**FIVE-YEAR REVIEW REPORT**  
**FOR**  
**PHOENIX-GOODYEAR AIRPORT (NORTH)**  
**SUPERFUND SITE**  
**GOODYEAR, ARIZONA**

**September 2006**

**Prepared for**  
**Contract No. 68-W-98-225/WA NO. 238**  
**United States Environmental Protection Agency**  
**Region 9**  
**75 Hawthorne Street**  
**San Francisco, California 94105**

**3-1**      **Area Map Showing Subunit A and C Wells and Treatment Systems**      **Figure**

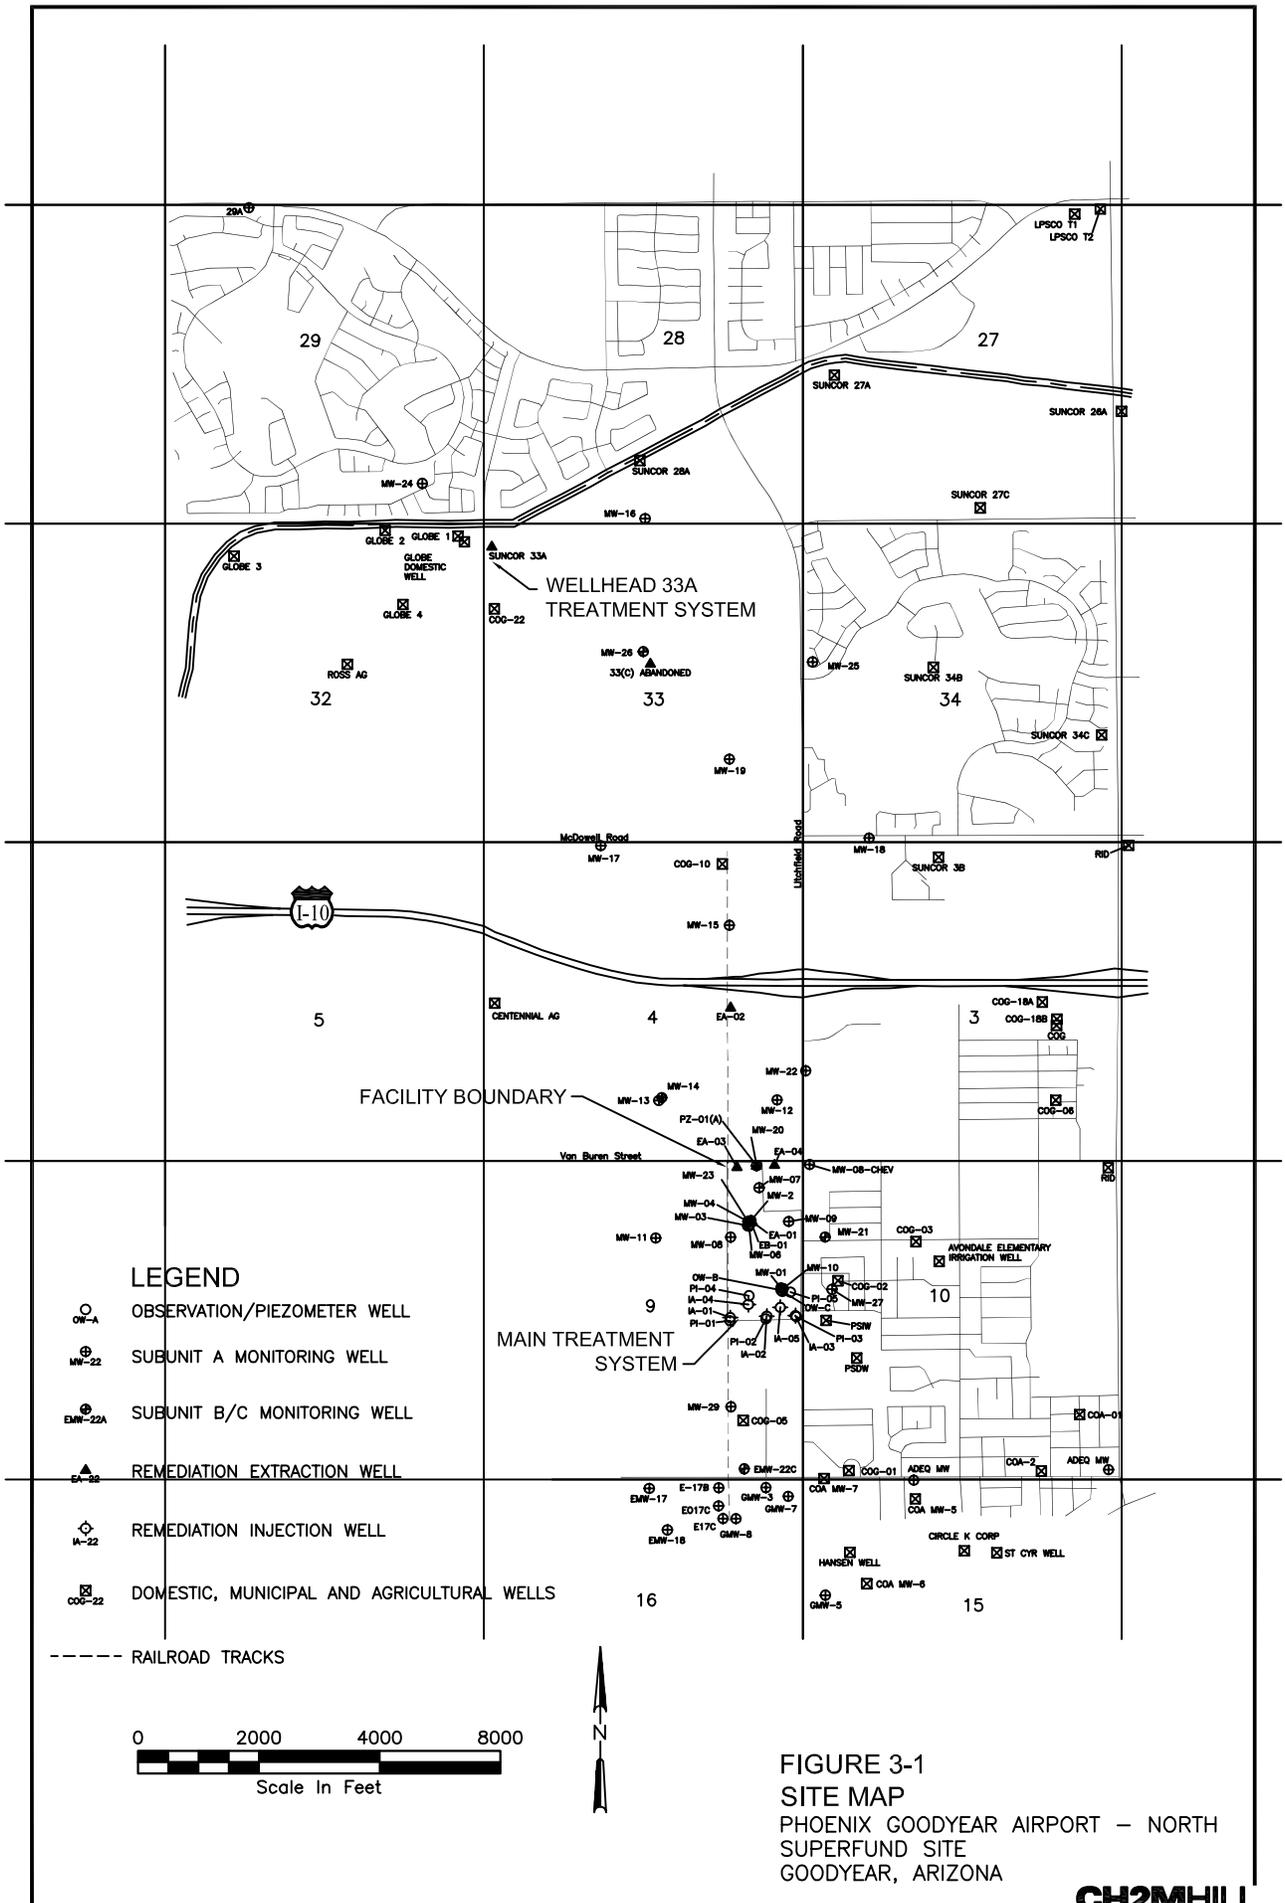
As of the fourth quarter 2005, TCE concentrations in Subunit A ranged from non-detect in some perimeter wells to 2,300 µg/l at MW-12, and perchlorate concentrations ranged from non-detect to 36.8 µg/l at MW-27. Increasing TCE concentrations in Subunit A monitor wells suggest that there is not adequate plume capture. This may be due to an insufficient number of Subunit A extraction wells and low flow rates in the wells that are in place. The current Site groundwater investigation is designed to better characterize the groundwater in the area aquifer. Additional monitoring and plume delineation is necessary to the north and northeast to demonstrate plume capture. The *Groundwater Monitoring Fourth Quarter 2005 and 2005 Annual Report* for the Site (ARCADIS, 2006a) reports increasing concentrations of TCE in MW-15, -16, -18 and -25, four monitoring wells located north of Interstate 10 (monitor well locations are shown on Figure 3-1). This increase may be due to lack of

capture in light of increased pumping of SunCor Well 3B drawing the plume in a more easterly direction, and/or due to decreased pumping from the west following closure of several Globe Corporation irrigation wells. There are no Subunit A sentinel monitoring wells east or northeast of these wells yet. However, the plume appears to be stable to the west/northwest as evidenced by TCE concentrations below the MCL in perimeter wells MW-17 and MW-24.

The remedy is currently not functioning as intended by the decision documents. The Site ROD requires capture and aquifer restoration as well as lowering of soil gas levels to protect the groundwater. The current groundwater remediation extraction well and monitor well networks do not provide complete plume capture or delineation. For example, TCE was detected above the MCL in COG-10 during April 2005, and the TCE concentration in monitor wells to the northeast and southeast of the plume are increasing.

Evaluate capture through installation of additional wells, update of groundwater flow model, and installation of additional extraction wells if needed.
